**WHITE LAKE TOWNSHIP
INTER-OFFICE MEMORANDUM**

**SUBJECT: Lakepointe
Final Site Plan Re-approval
Revised Planned Development Agreement Approval**
Located on the northeast corner of Union Lake Road and Carpathian, consisting of approximately 13.32 acres. The property is currently zoned PD (Planned Development). Identified as parcel number 12-36-177-008.

RE: Lake Pointe – Final Site Plan and Final Engineering Plan –7th Review

**RE: Lake Pointe – Final Site Plan Backcheck #4
Parcel Number 12-36-177-003**

SCALE: 1/8" = 1'-0"

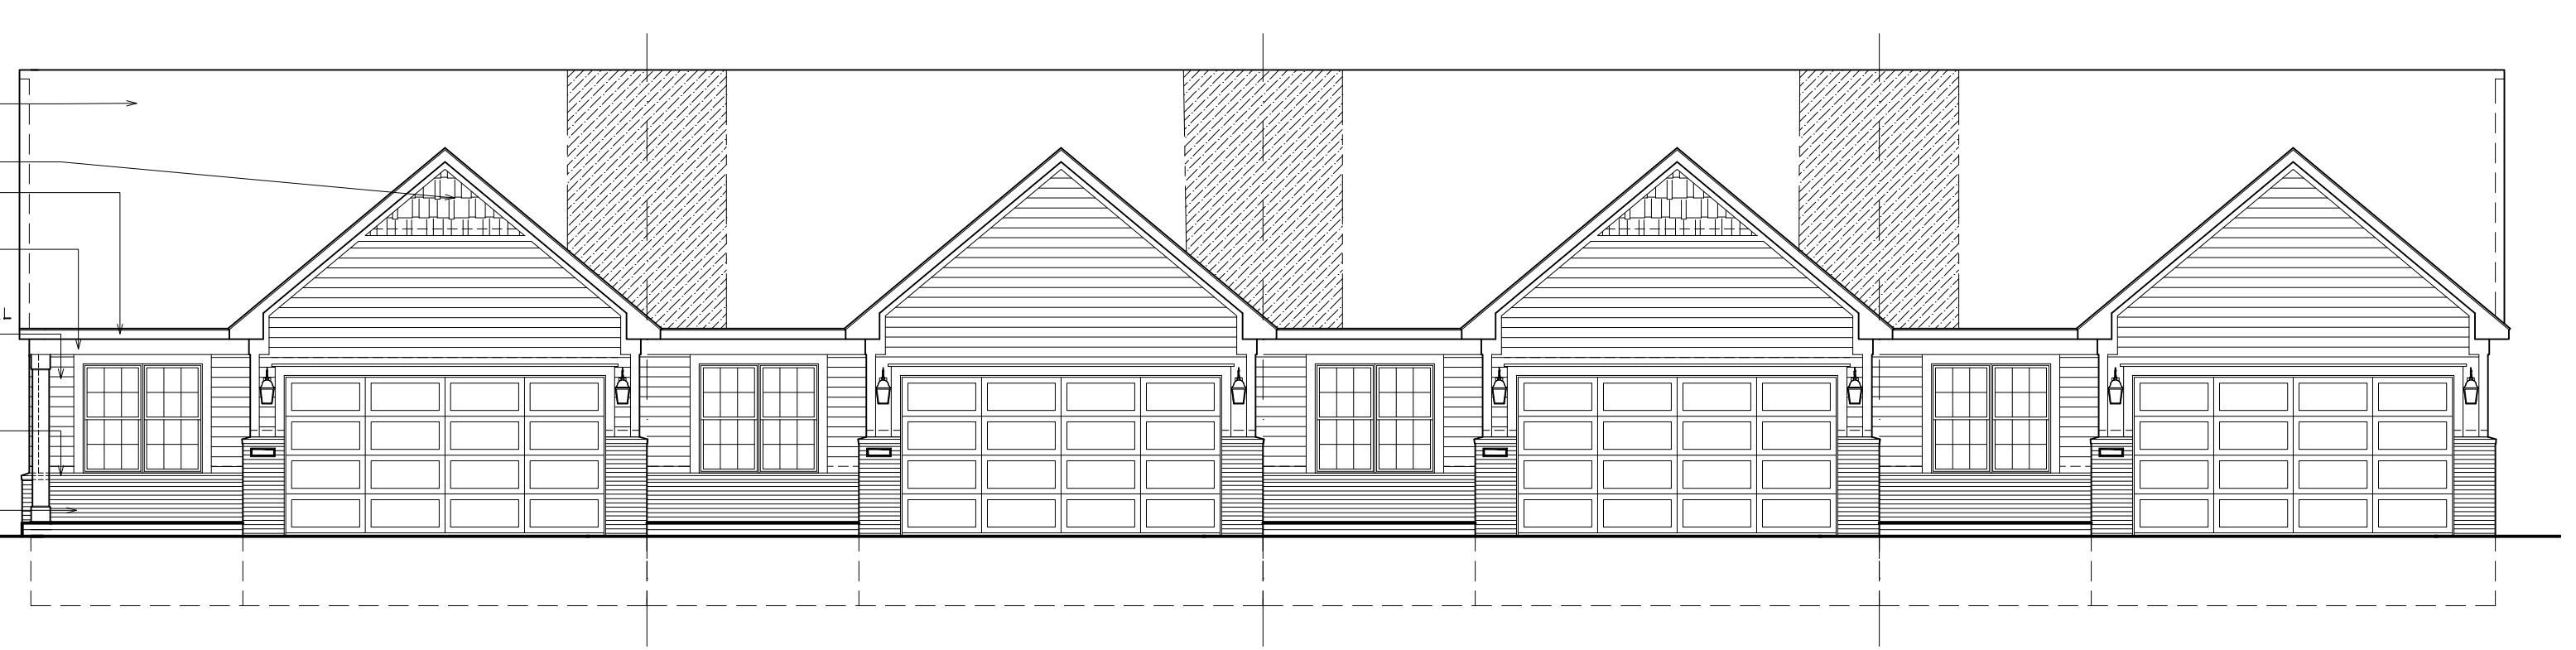
- As stated in previous correspondence (dated February 22, 2021), **the building materials shall be labeled on the building elevations, Sheets A201 and A203.** (Comment outstanding). (Comment remains outstanding). (Comment addressed. Material notations have been added to the elevations).

LEFT ELEVATION
 SCALE: 1/4"=1'-0"

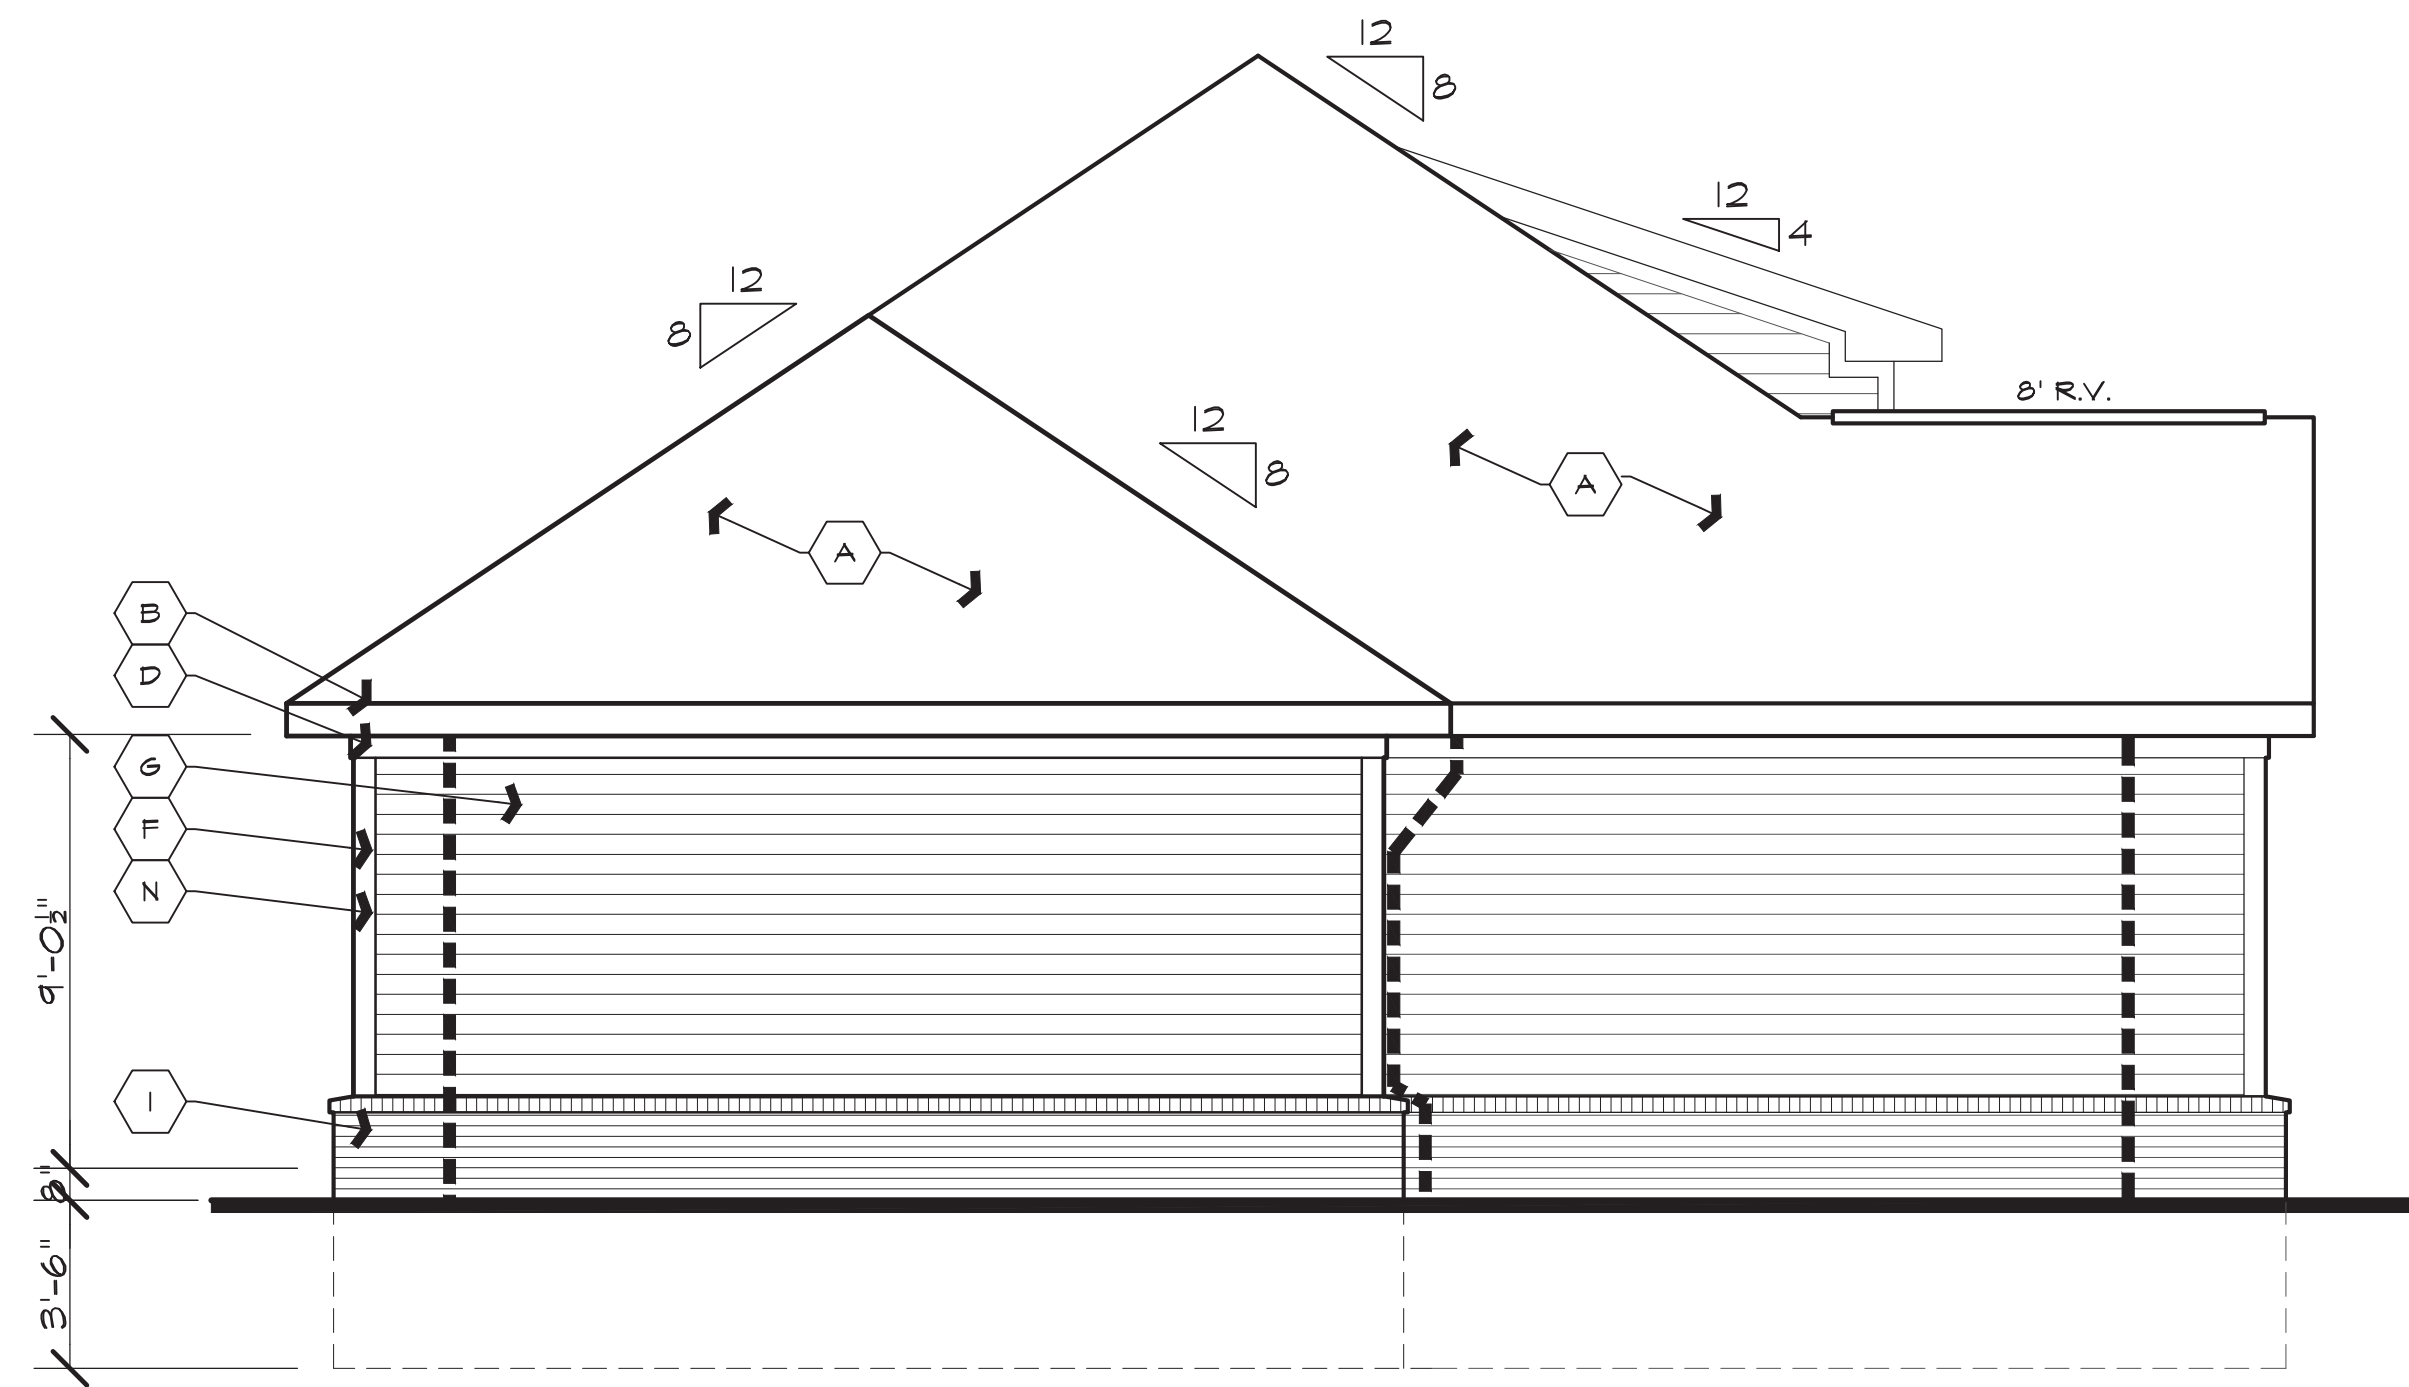
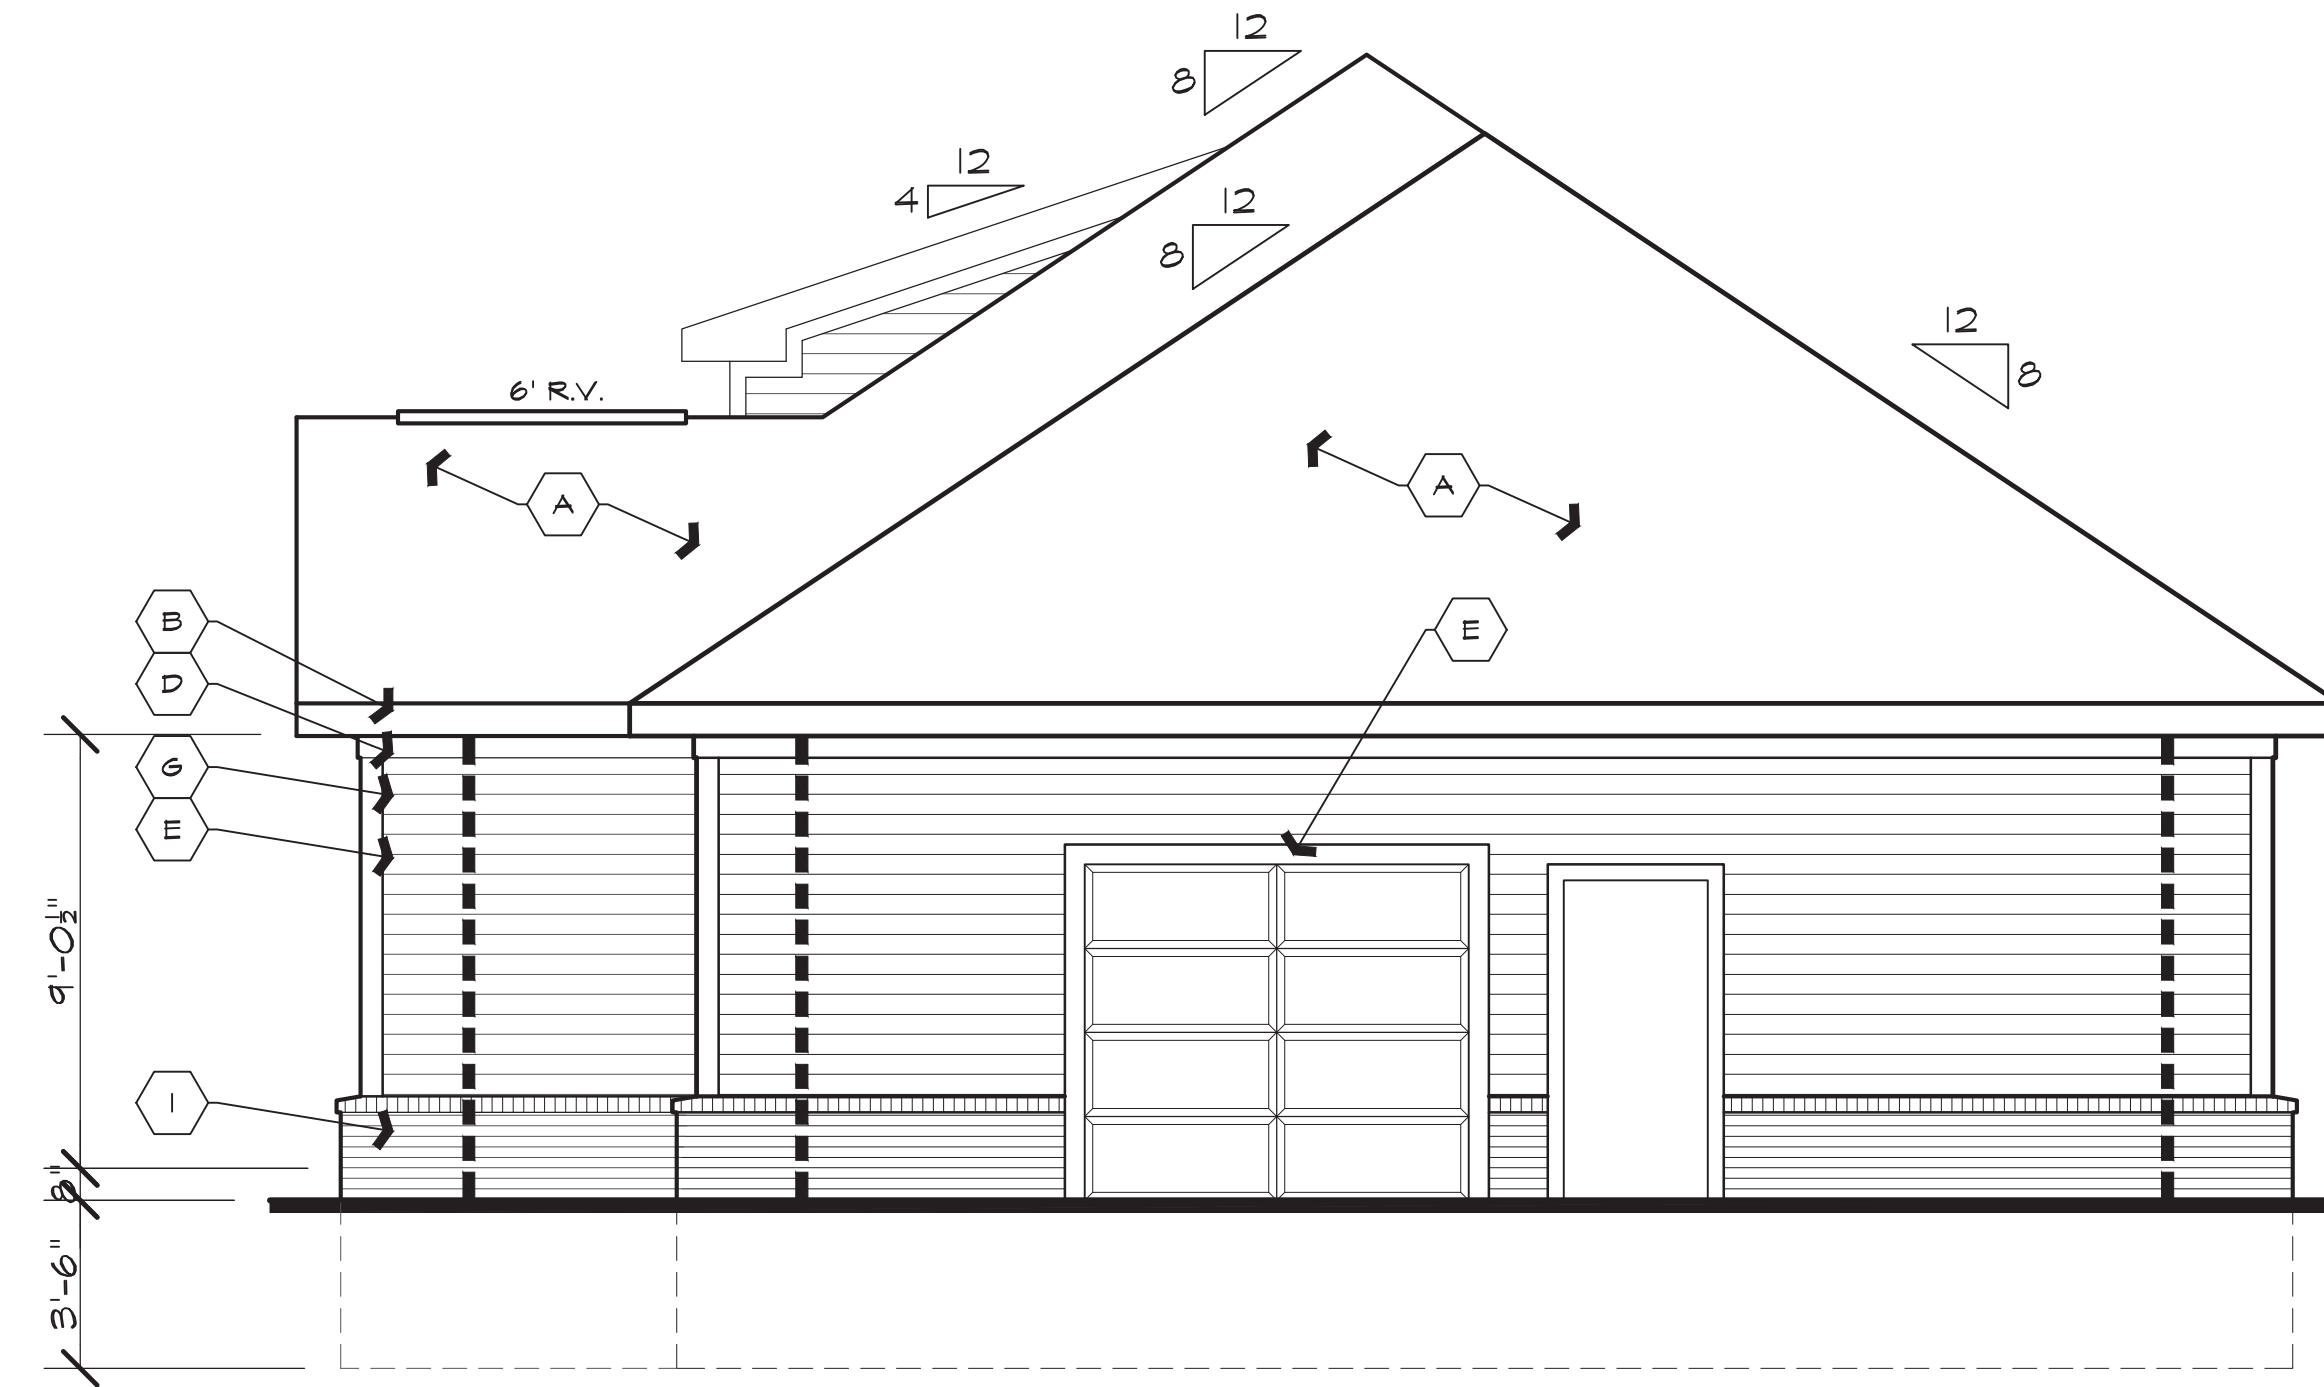
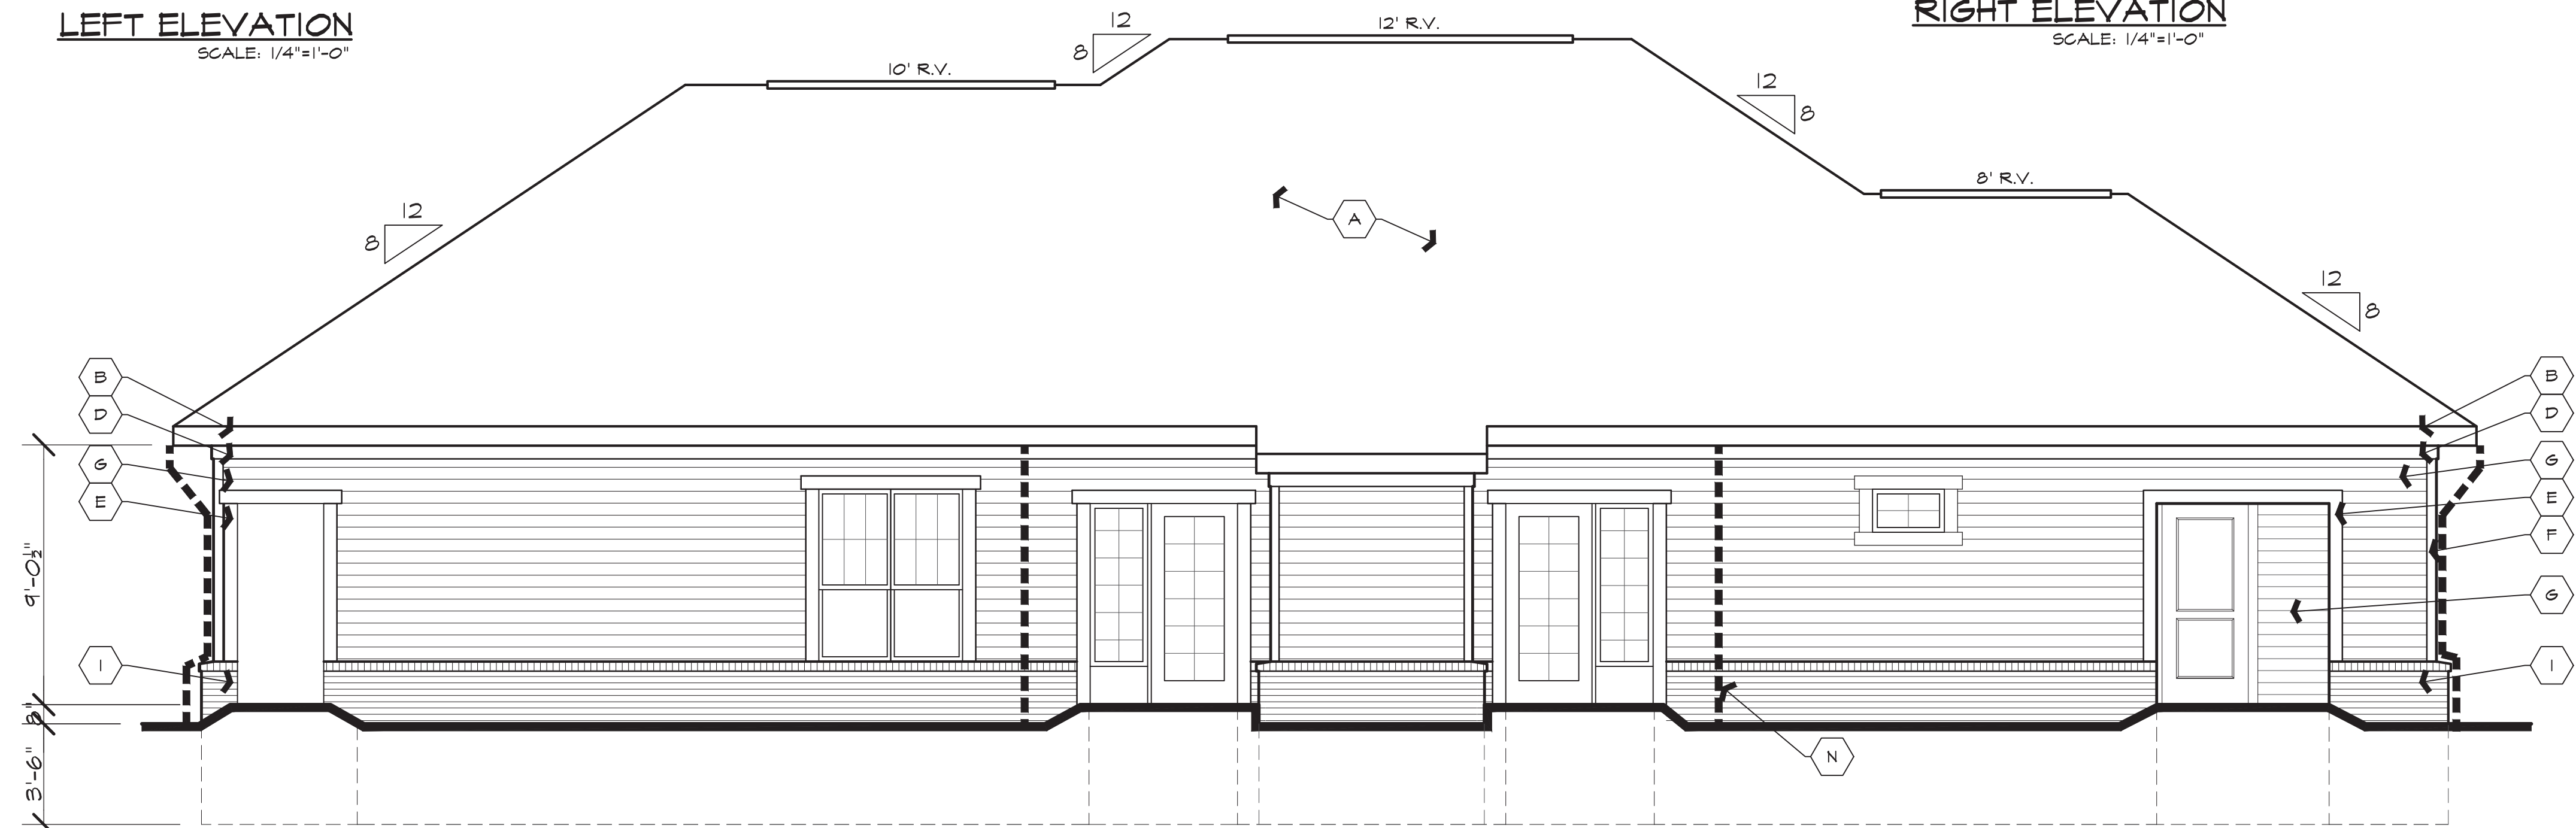
- As stated in previous correspondence (dated February 22, 2021), **elevations and building material details shall be provided for the clubhouse building.** (Comment addressed. Community building elevations have been provided).
